Re: **Flood Plain Determination, for 2662 Hwy 93 South, Darby, Mt.
Jeffrey & Barbara Black:
Your Denial Letter of January 12, 2012**

This letter is a PRELIMINARY REQUEST to APPEAL your Denial letter of January 12, 2012 denying a proper floodplain determination for the above referenced project as previously requested. A formal Request to Appeal your determination is pending.

Comparison Review of FEMA and Flood Plain Management Study

21/24

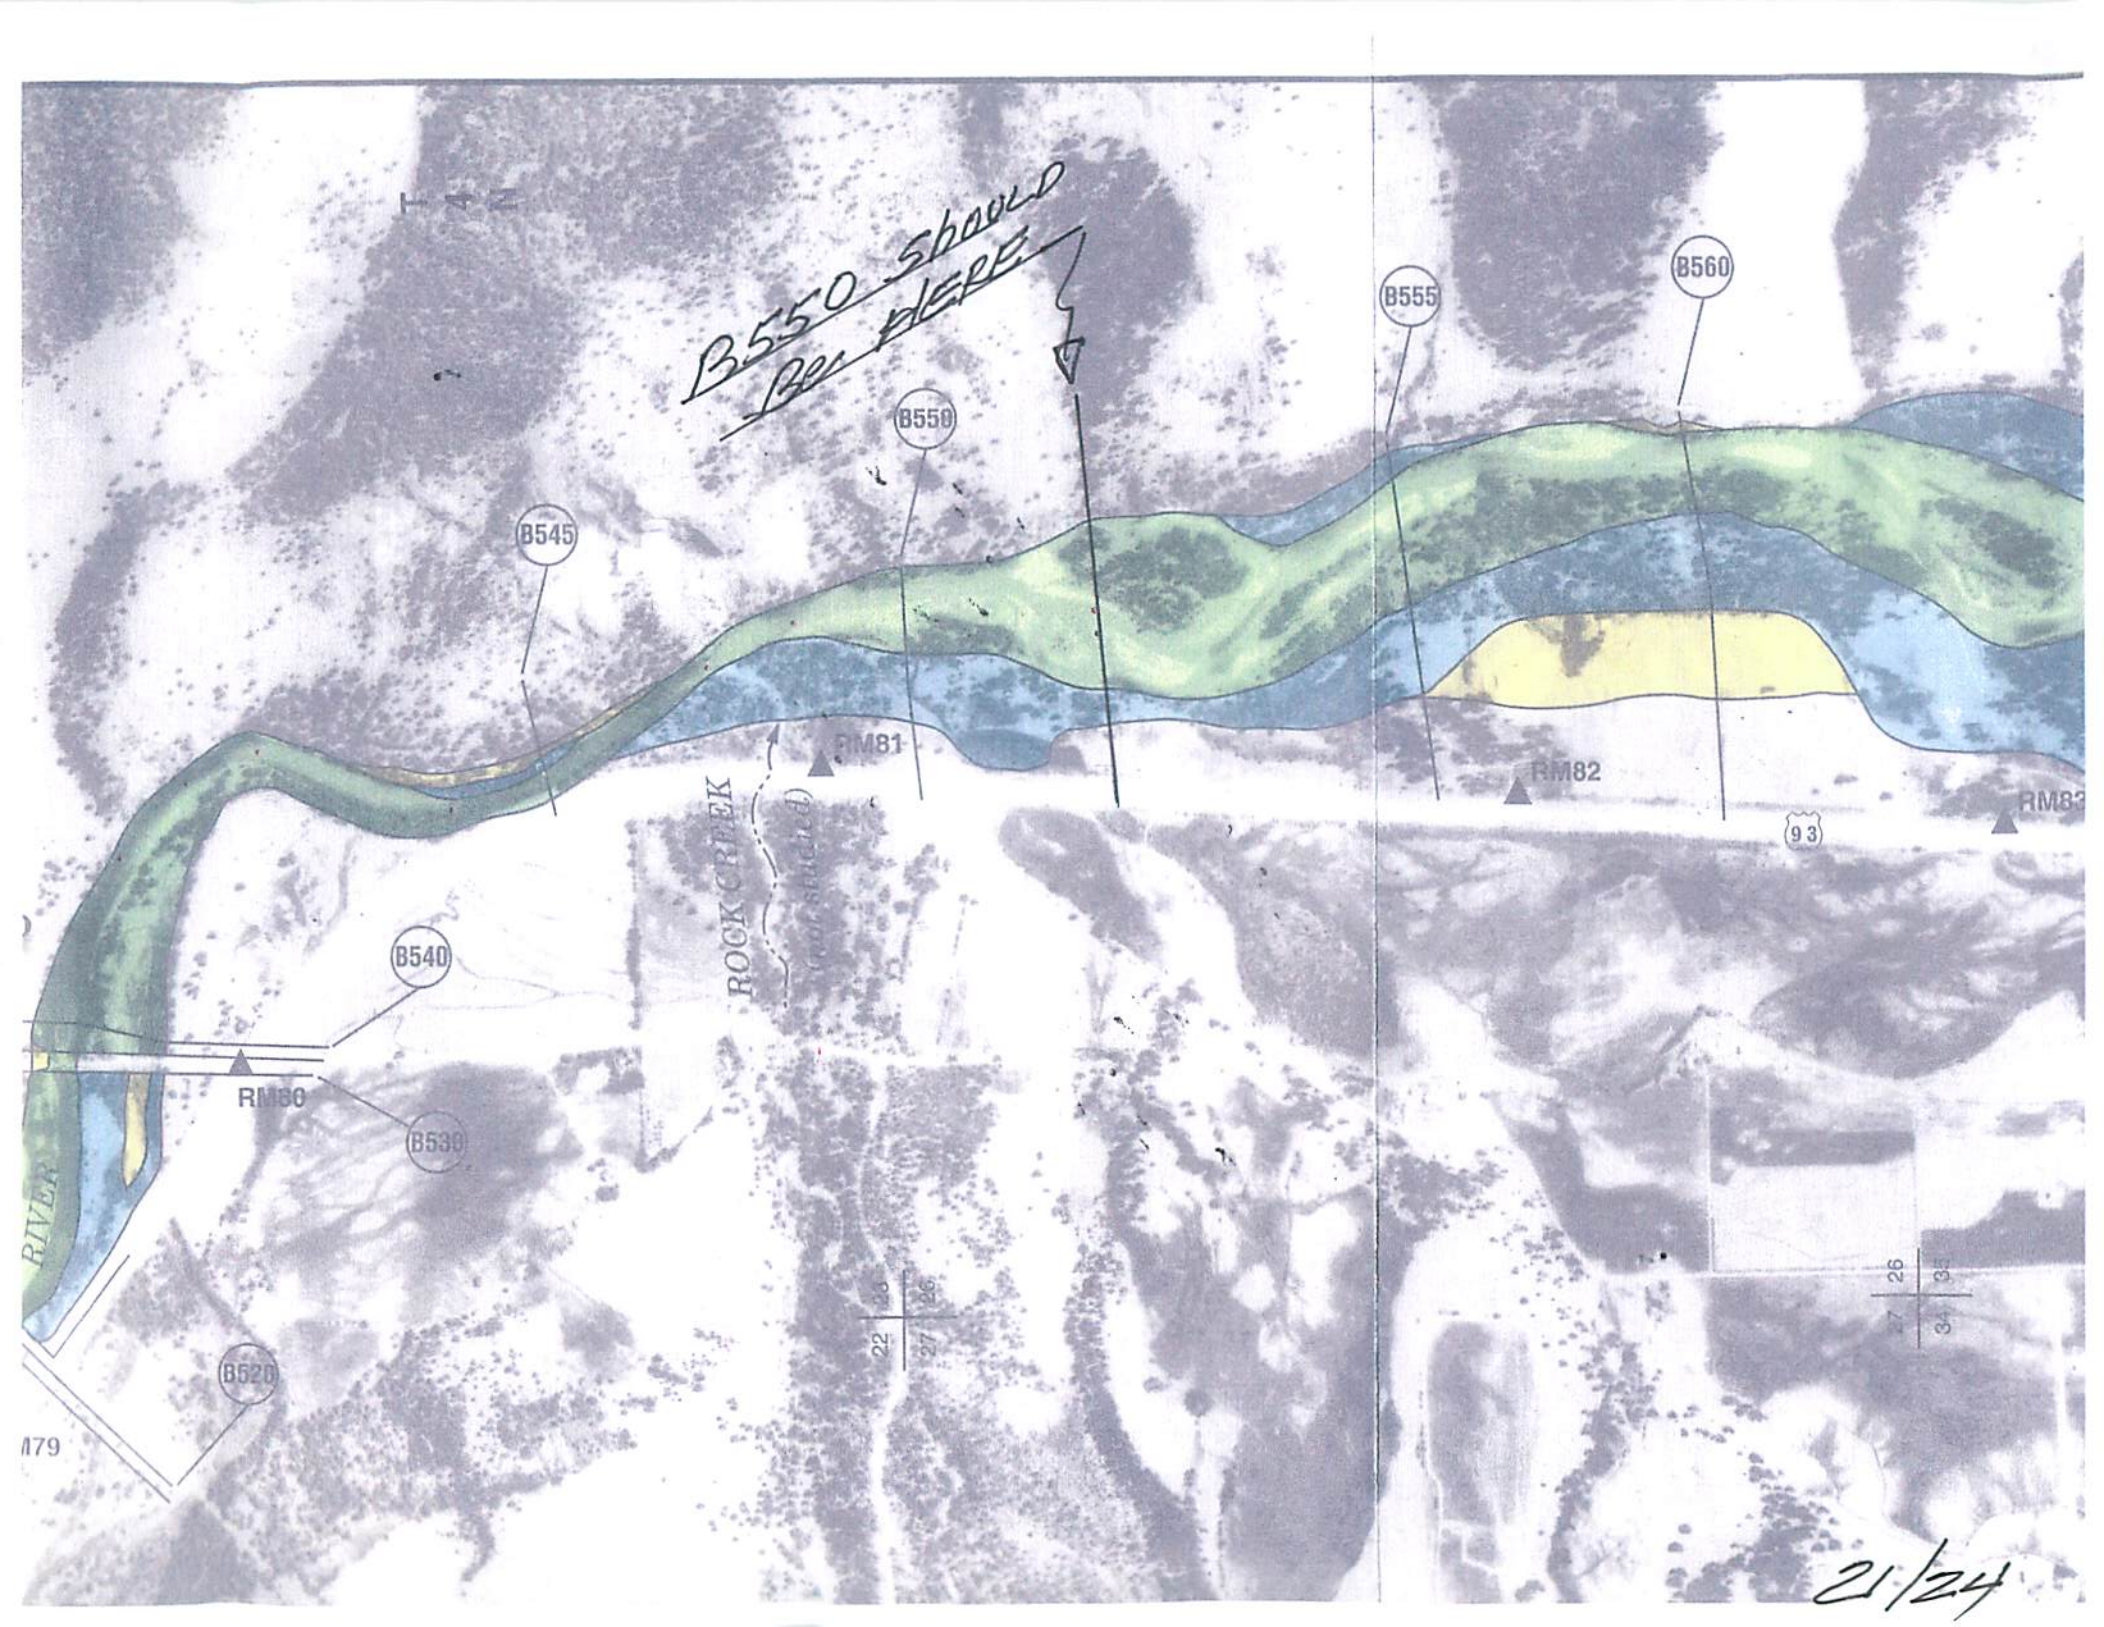
1. CROSS SECTION B550 is drawn on the Sheet 21 of 24 in the wrong location. [Floodplain Management Study of the Bitterroot River dated November 1995] It needs to be moved up stream Approximately 1,000 lin. ft, and then it matches the profile, and the other data then falls correctly in Place. The actual cross section fit this site rather than where it is presently shown.

B550 should be here

* B550 is drawn on the plat sheet 21 of 24 at 262100 >>should be @ 263100
Its drawn 1000 ft off.

1. FEMA profile 11P is not drawn the same as the FPMS sheet 11 of 13. Copy of the comparison attached. I made a composite sheet out of both so that they can be easily compared.
2. Cross Section Notes, Actual for B550 do not match the location where B550 is drawn on sheet 21 of 24.
3. Cross Section B550 fit's the new location where shown on the Aerial Photo, Copy attached. When this Cross section location is then plotted on the Aerial Photo it then matches the profile and all slopes and Station then match out.
